April 27, 2000  
IPN-00-033

Subject: **Indian Point 3 Nuclear Power Plant**  
**Docket No. 50-286**  
**Proposed Technical Specification Changes Associated With**  
**Pressure-Temperature and Overpressure Protection System**  
**Limits for Up To 16.2 Effective Full Power Years**

**PROPOSED REVISIONS TO TECHNICAL SPECIFICATION CHANGES ASSOCIATED  
WITH PRESSURE-TEMPERATURE AND OVERPRESSURE PROTECTION SYSTEM  
LIMITS FOR UP TO 16.2 EFFECTIVE FULL POWER YEARS**

FIGURE 3.1.A-1

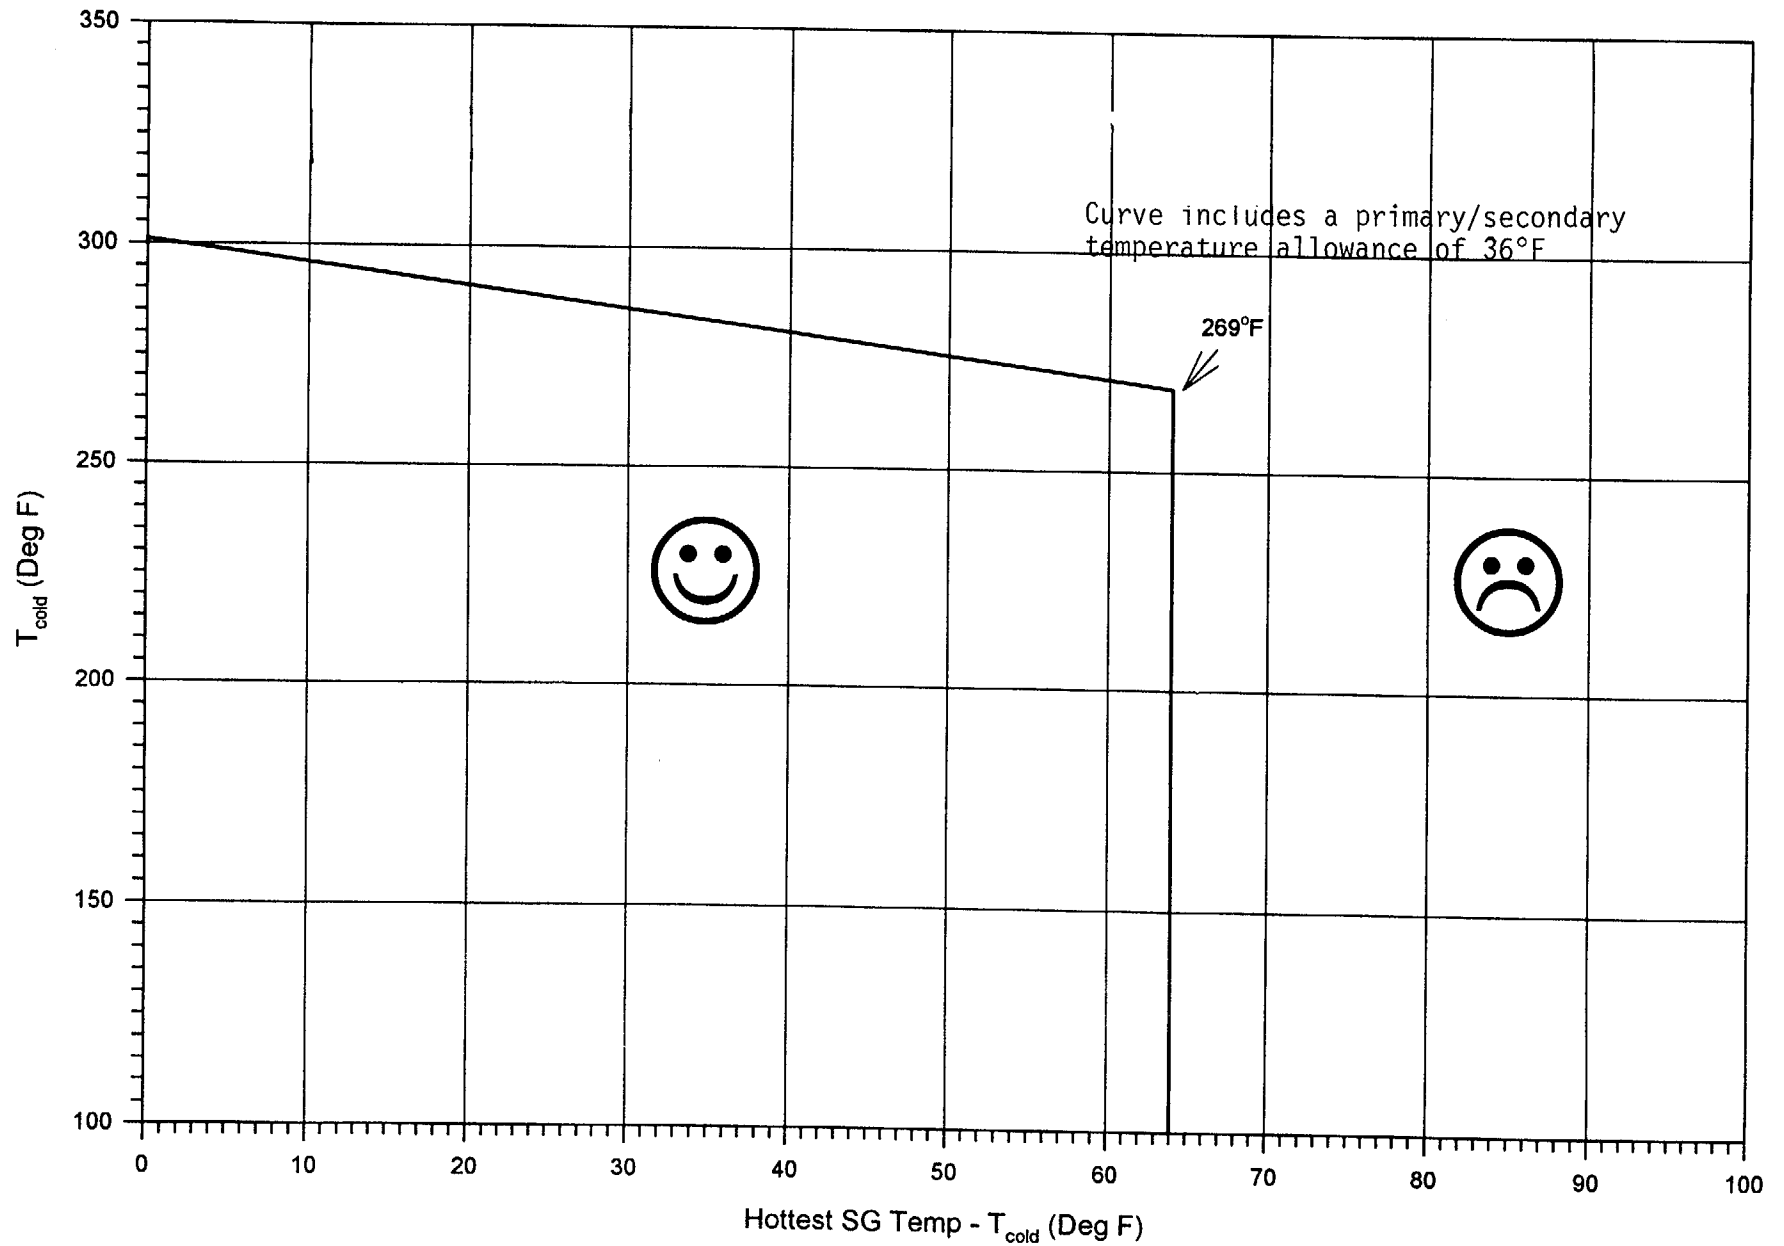
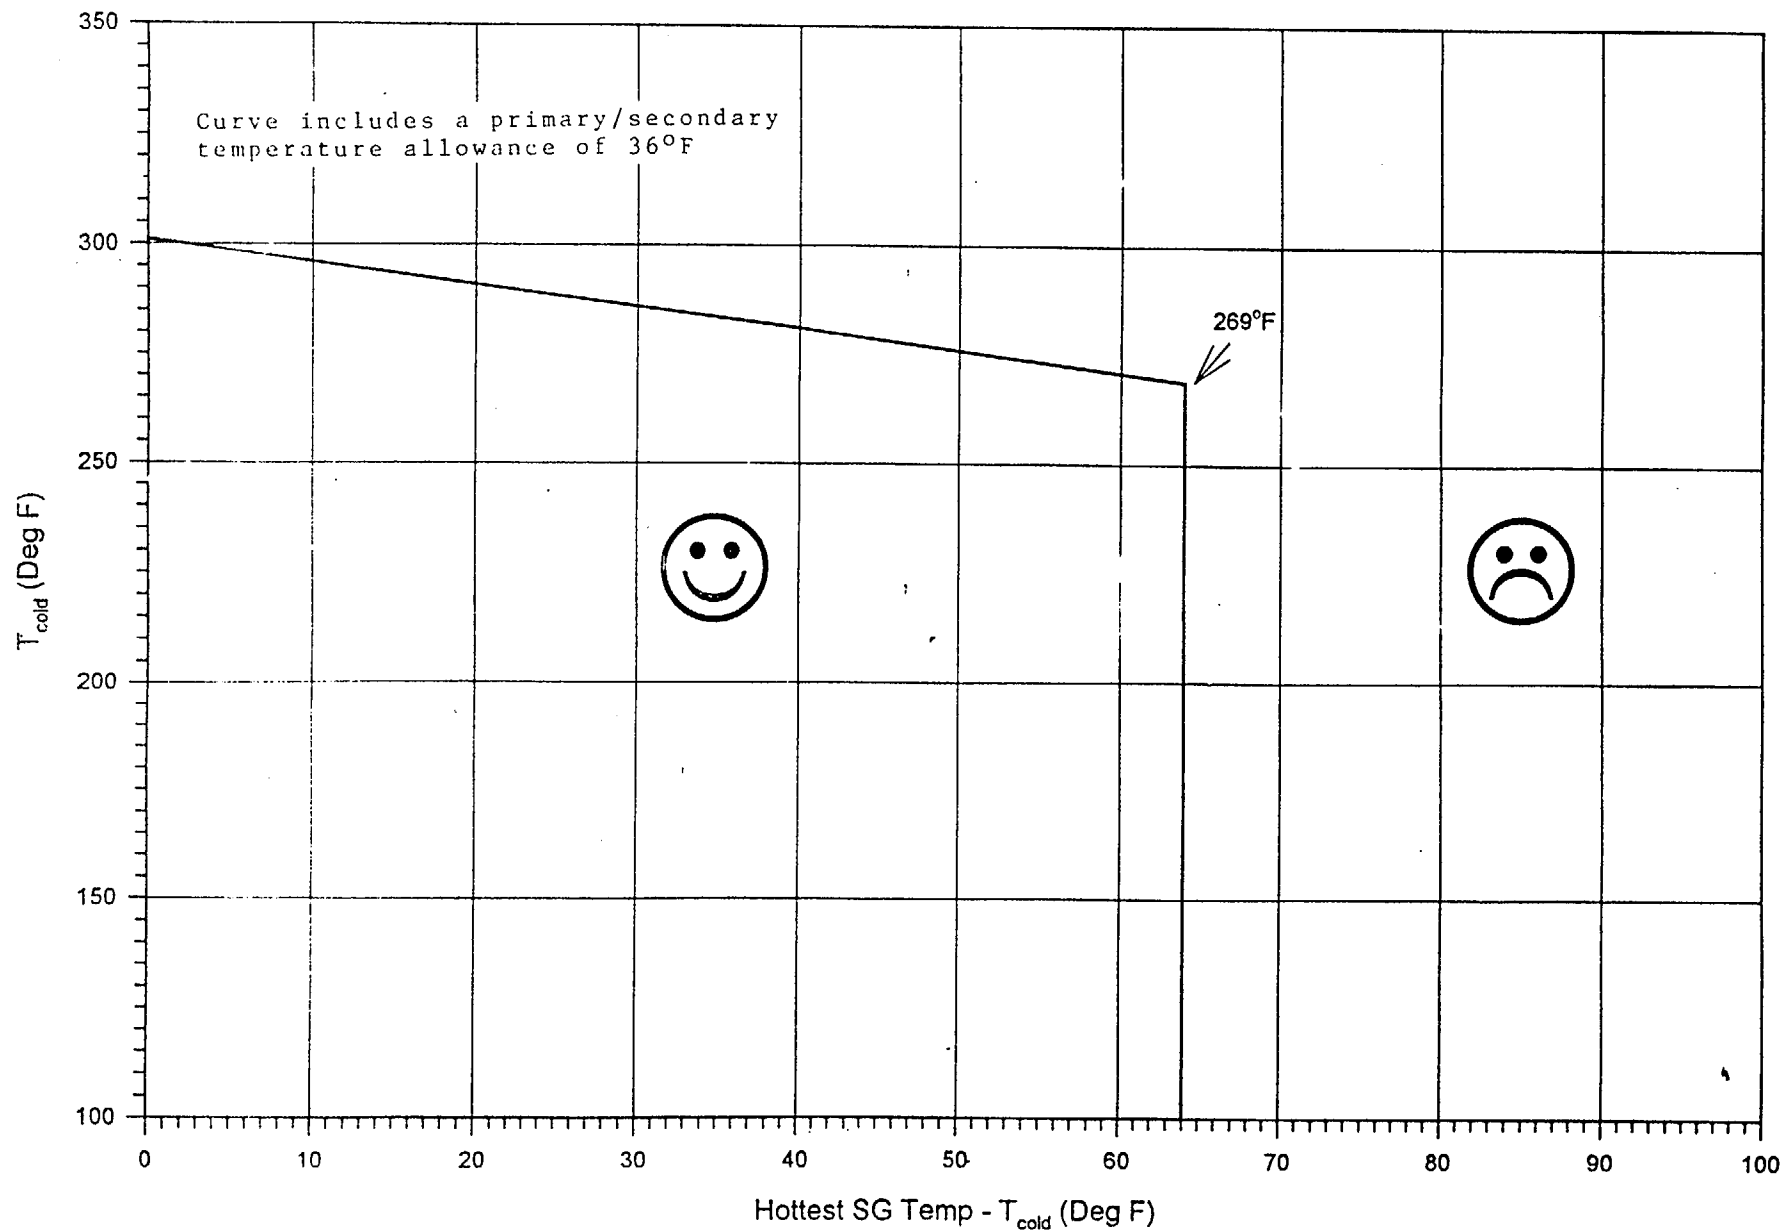
2. **Figure 3.1.A-1**

Replace current figure title with:

Secondary Side Limitations for RCP Start With  
Secondary Side Hotter Than Primary, ~~13.3 EFPP~~ **16.2 EFPP**

Secondary Side Limitations for RCP Start With Secondary Side Hotter Than Primary, 16.2 EFPY

FIGURE 3.1.A-2

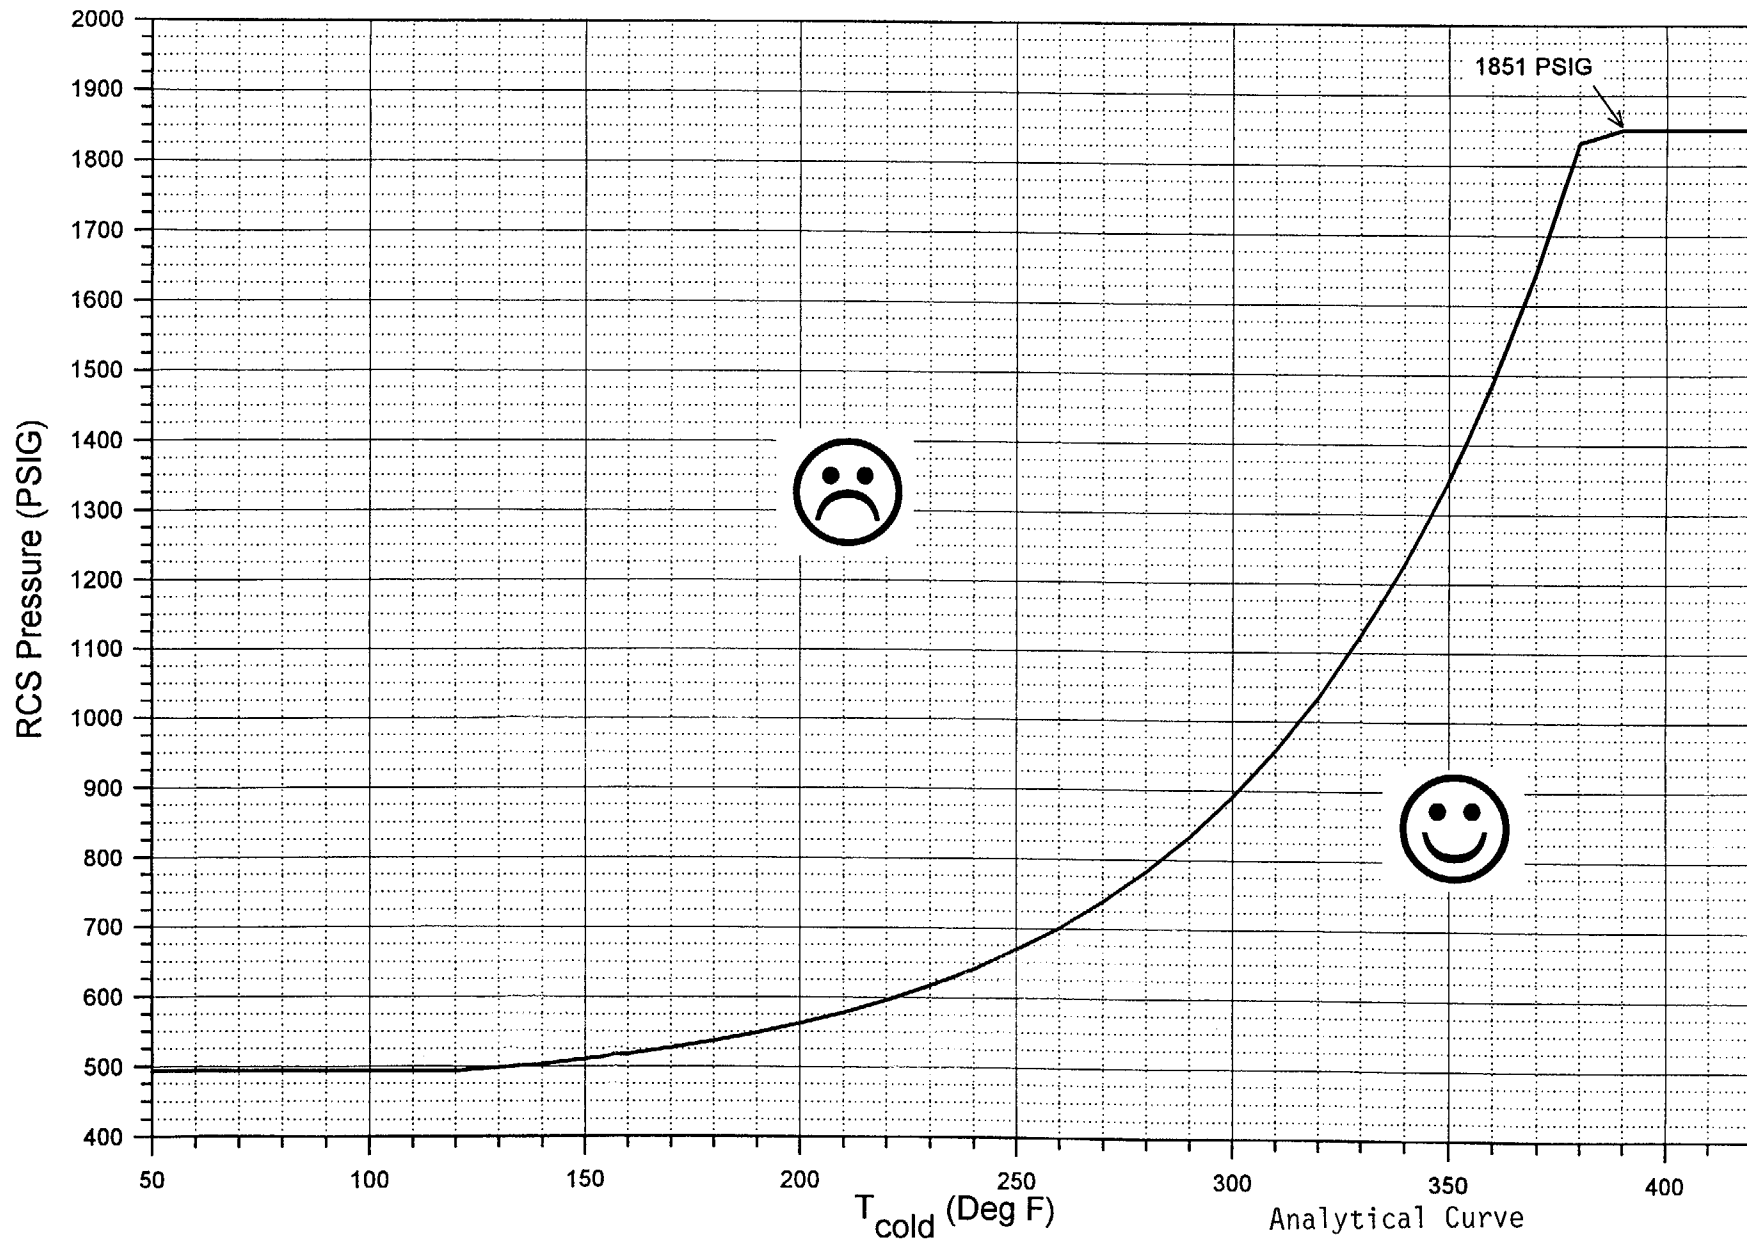
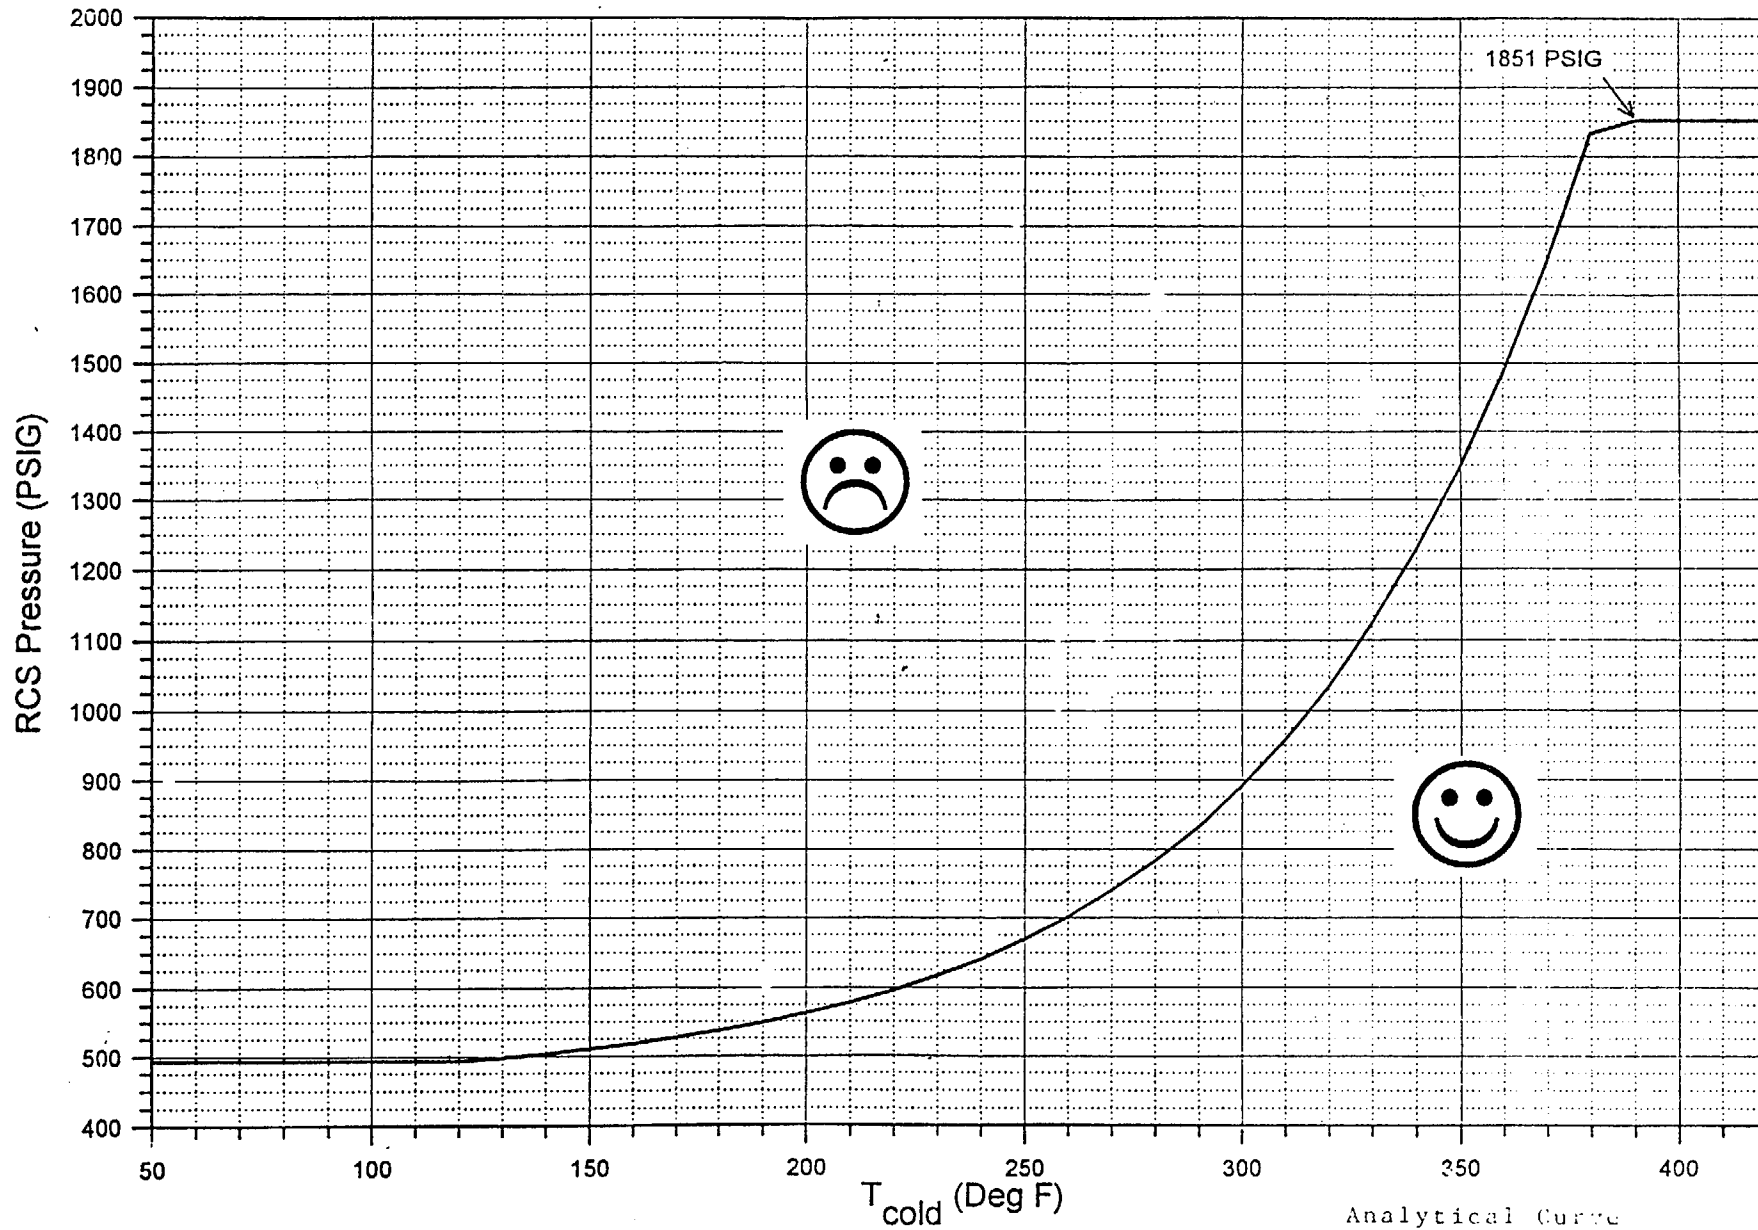
3. **Figure 3.1.A-2**

Replace current figure title with:

Maximum Allowable Nominal PORV Setpoint for the  
Low Temperature Overpressure Protection System (OPS), ~~13.3 EFPP~~ **16.2 EFPP**

Maximum Allowable Nominal PORV Setpoint for the Low Temperature Overpressure Protection System (OPS), 16.2 EFPY
